ADDENDUM NO. 1

TO: PLANS AND SPECIFICATIONS FOR THE STATE OF MISSOURI

Improvements to HVAC
Broadway State Office Building
Jefferson City, MO
PROJECT NO.: O2324-01

SHEET TITLE:
**SECOND FLOOR - HVAC
PLAN**

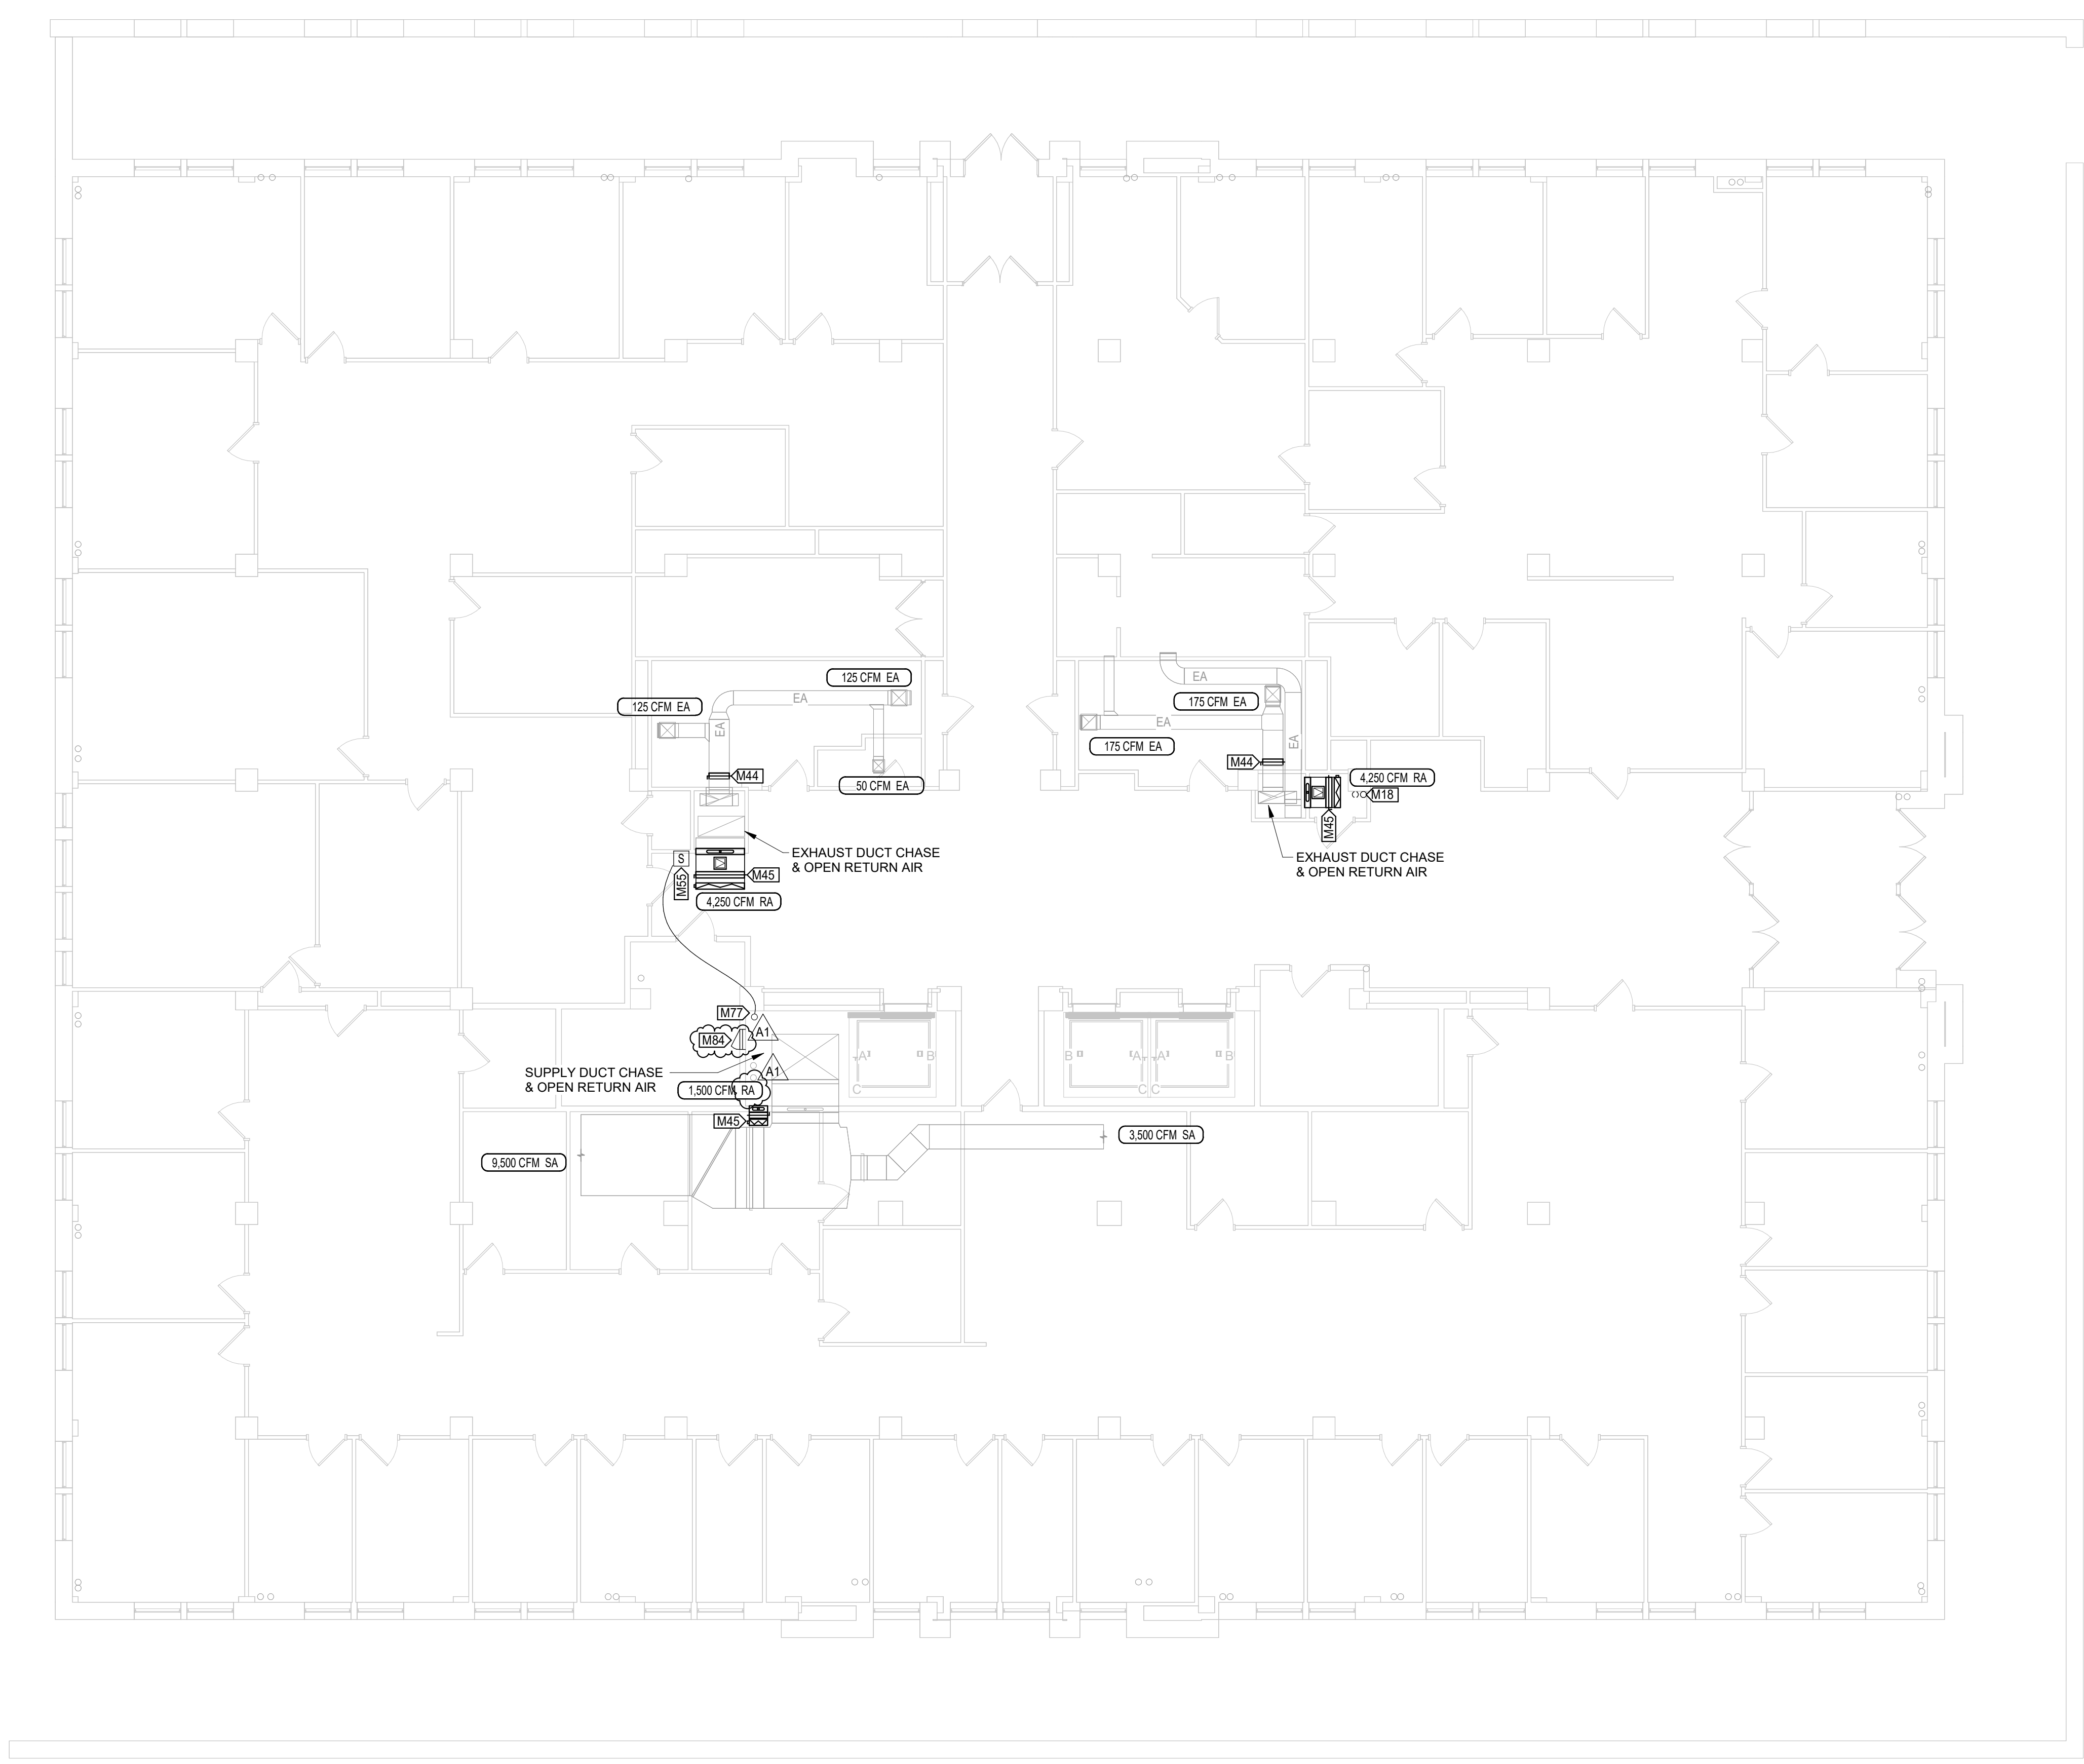
1. Sheet M102 – Second Floor - HVAC
 - a. Revise airflow balance tag at Southeast RA shaft.
 - b. Add keynote M84 as follows:
“PROVIDE AND INSTALL FIRE-RATED, 24"X36", LOCKABLE, STEEL ACCESS PANEL.”
 - c. See revised Sheet M102, attached.
2. Sheet M108 – Eighth Floor - HVAC Plan
 - a. Revise keynote M49 as follows:
“EXISTING 2.5" ROOF SLAB TO BE REMOVED FROM INSIDE FACE OF JOIST TO INSIDE FACE OF JOIST FOR OPENING. OPENING LENGTH ALONG JOIST SHALL NOT EXCEED 36". TRANSITION DUCT AND ROUTE DUCT UP THROUGH NEW CURB TO EF-1 ABOVE. CONTRACTOR SHALL COORDINATE WITH THE ROOFING SYSTEM MANUFACTURER TO ENSURE THAT THE WARRANTY ON THE EXISTING VERSICO ROOFING SYSTEM IS MAINTAINED.”

SHEET TITLE:
**EIGHTH FLOOR - HVAC
PLAN**

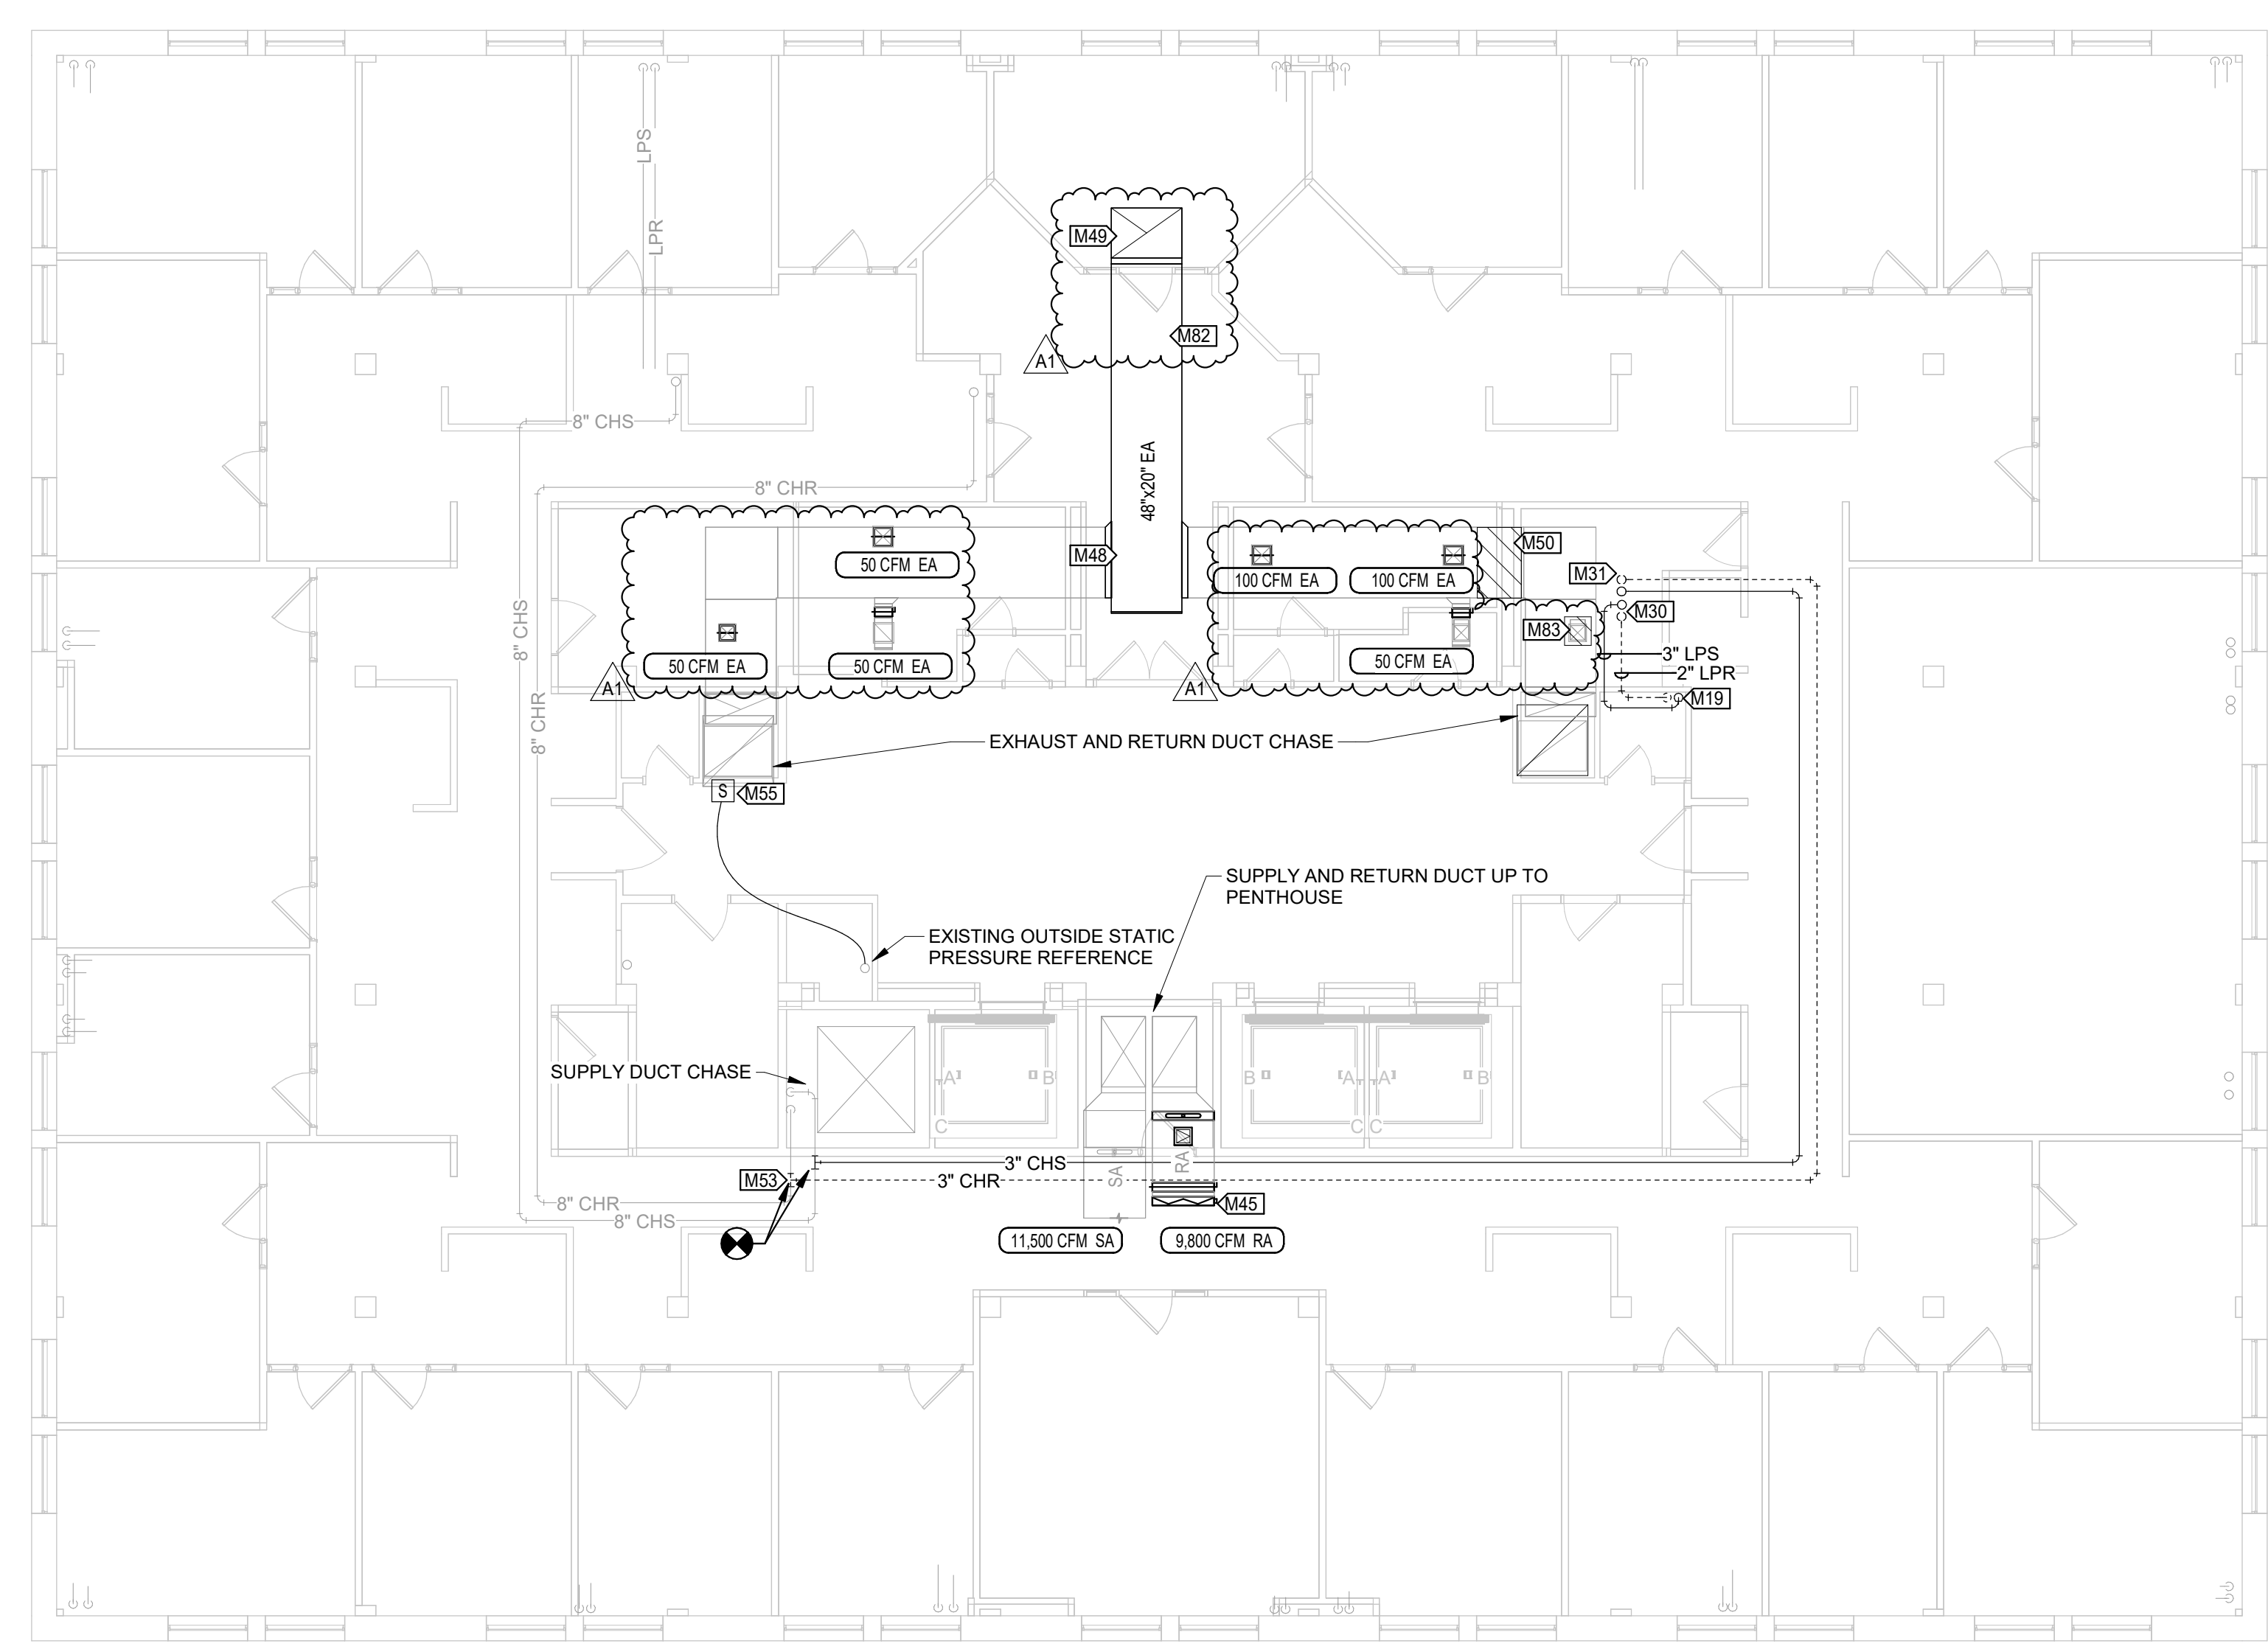
- b. Add keynote M82 as follows:
“OFFSET EXISTING SUPPLY AIR DUCT IN THIS AREA AS NECESSARY TO ROUTE EXHAUST DUCT.”
 - c. Add keynote M83 as follows:
“CAP EXISTING BRANCH DUCT ABOVE CEILING.”

- d. See revised sheet M108, attached.
3. Sheet M601 – Mechanical Schedules
 - a. Revise Shell and Tube Heat Exchanger Schedule
 - b. Revise Fan Array Schedule.

SHEET TITLE:
**AIRFLOW CONTROL
SCHEMATIC DIAGRAM**

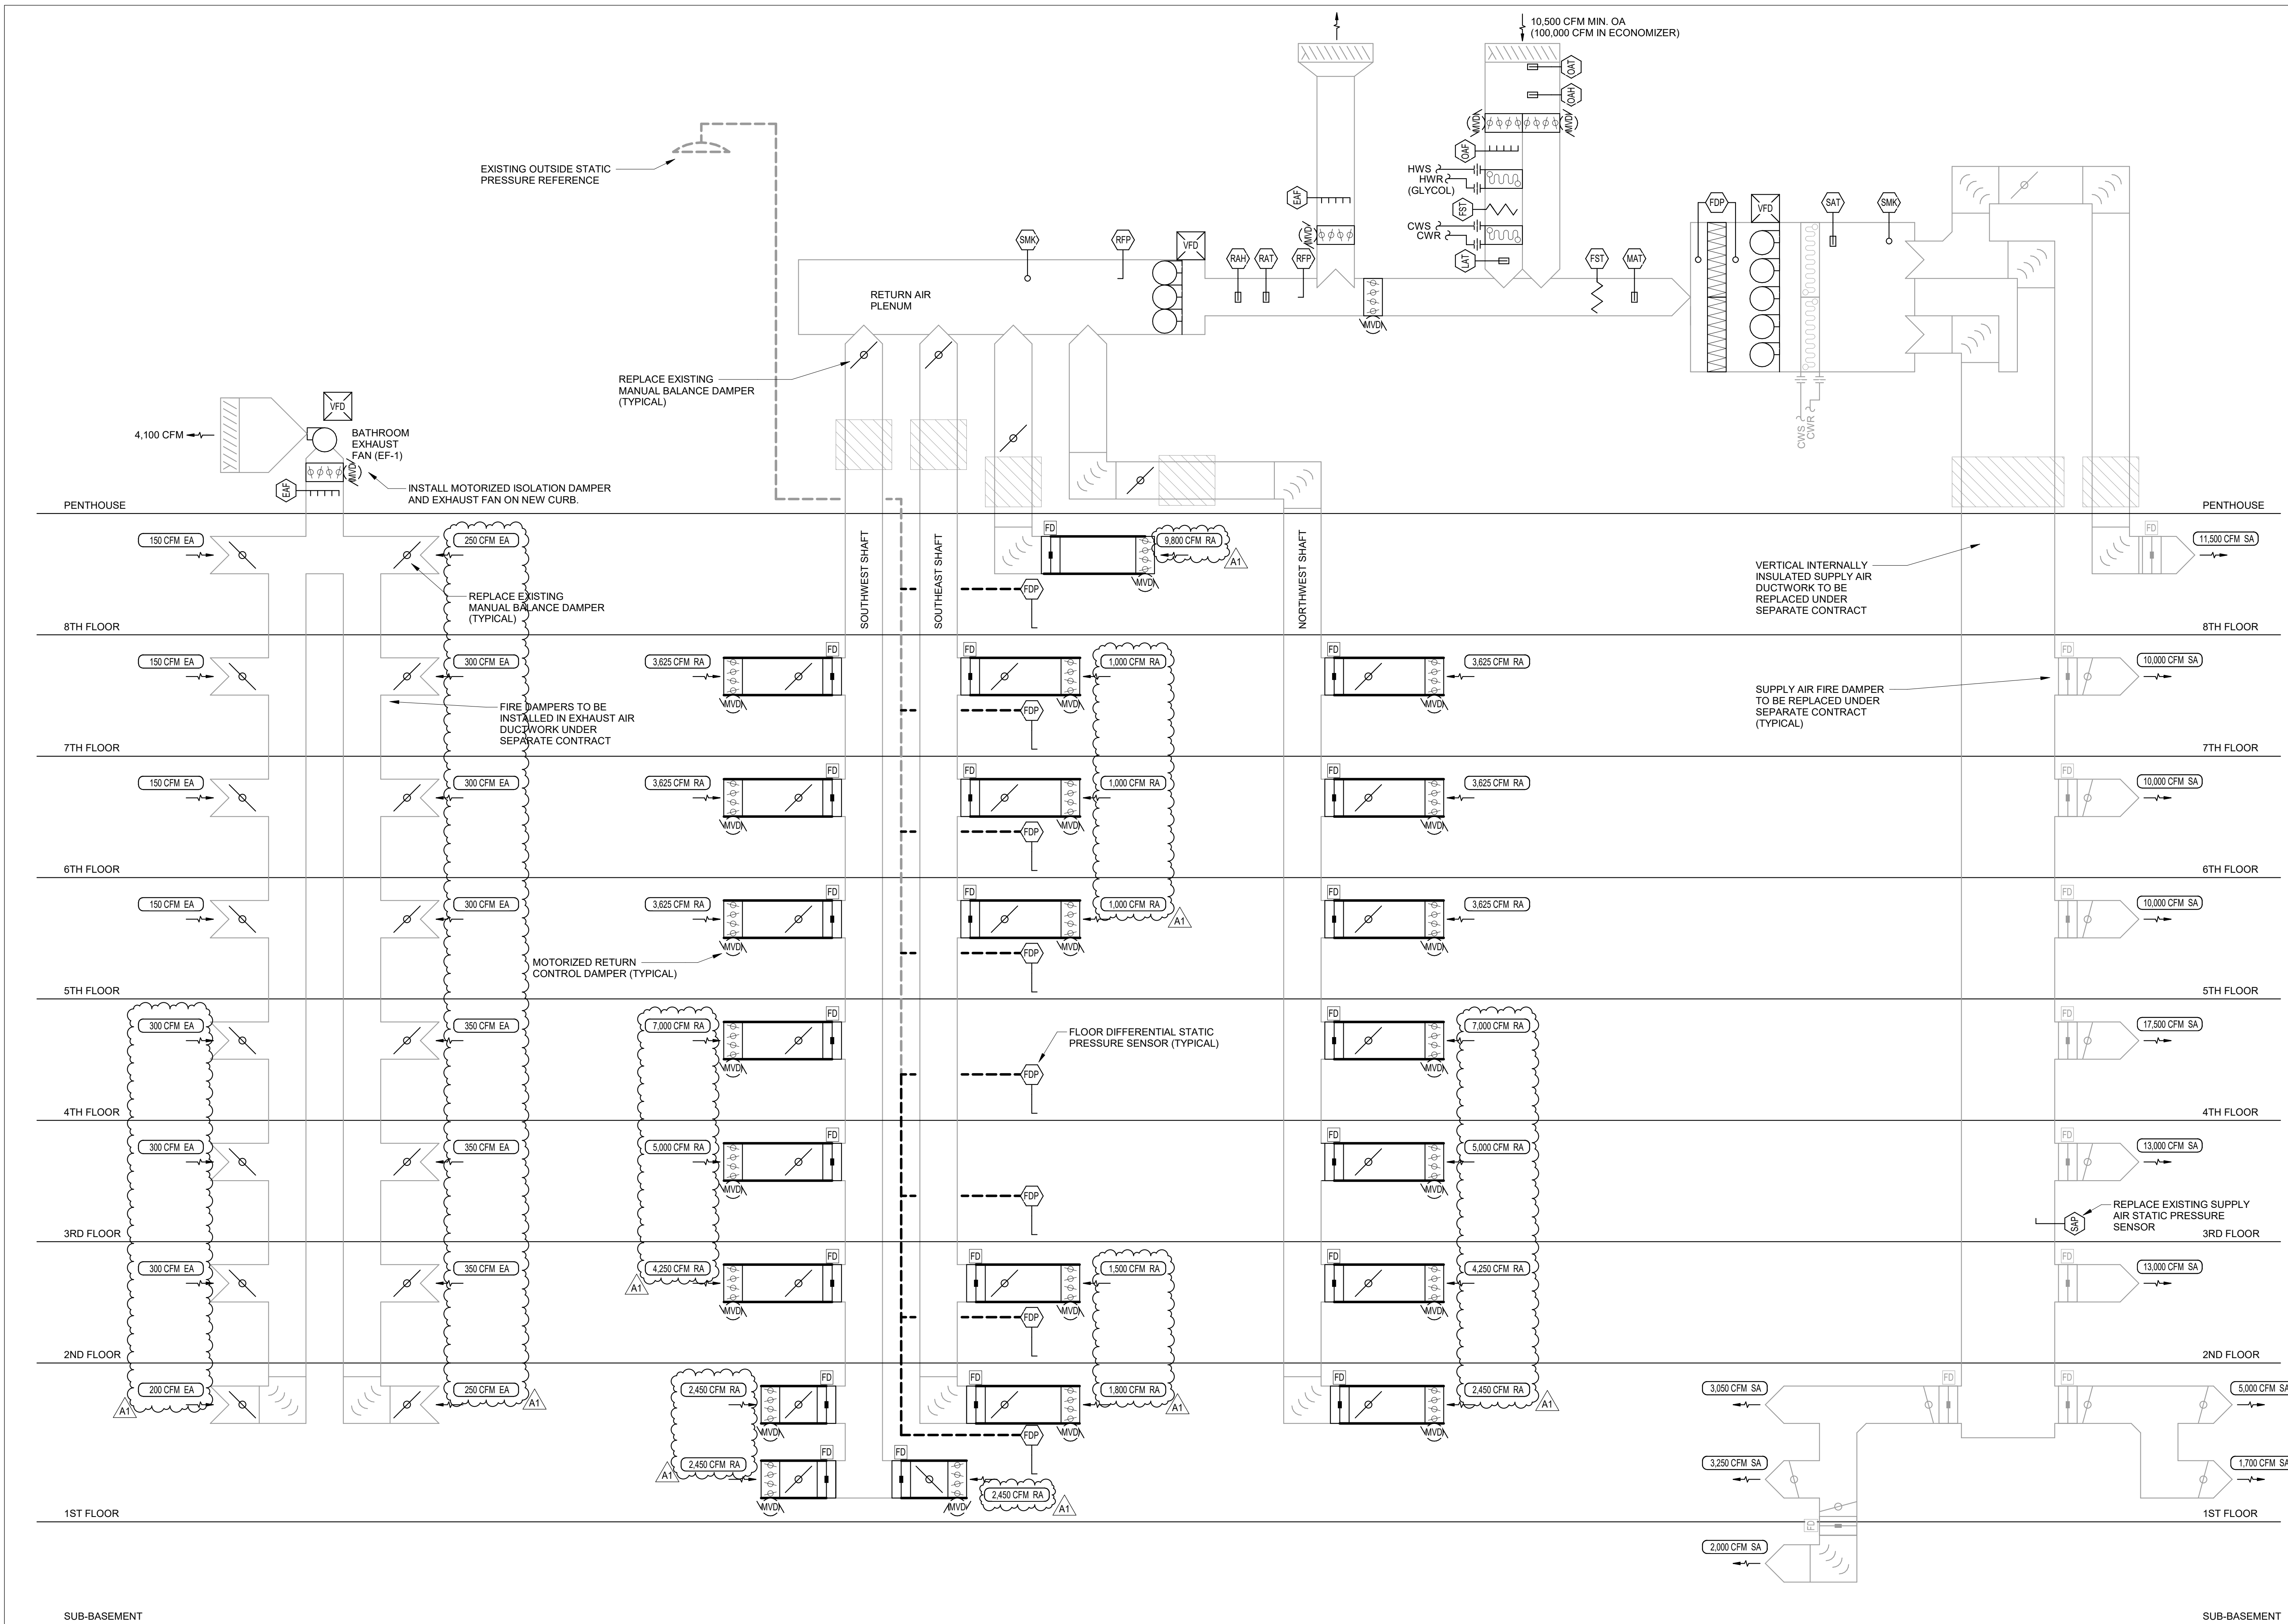
- c. See revised Sheet M601, attached.
 4. Sheet M701 – Airflow Control Schematic Diagram
 - a. Revise airflow tags throughout.
 - b. See revised Sheet M701, attached.
